From: Danielle Deegan
Sent: 26/04/2023 10:46:09 AM
To: Council Northernbeaches Mailbox
Subject: TRIMMED: DA2023/0299, 29, 31 and 35 Reddall Street, Manly
Attachments: FINAL SUBMISSION from 28 Reddall Street 20230426.pdf;

LETTER OF OBJECTION TO DA 2023/0299

**Demolition works, subdivision of three lots into five and construction of five new dwelling houses with swimming pools, associated landscaping and parking
29, 31 and 35 Reddall Street, Manly.**

Figure 5. Section A-A, demonstrating three storeys (source: Wolski Coppin Architecture)

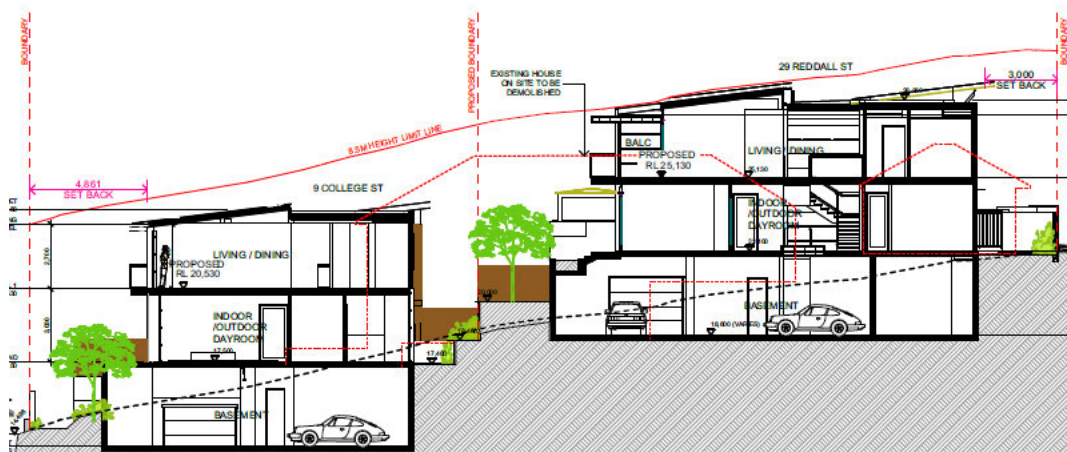
The MDCP states that buildings must not exceed 2 storeys. All five dwellings are three storeys, with the basement storeys extending beyond the footprint of the dwellings above. Figure 5 below shows a section through 29 Reddall Street and 9 College Street.

The non-compliances with the number of storeys results in substantial visual bulk particularly where the basement protrudes above ground level. The basement levels are visually dominant in the College Street streetscape where they have an unacceptable visual impact.
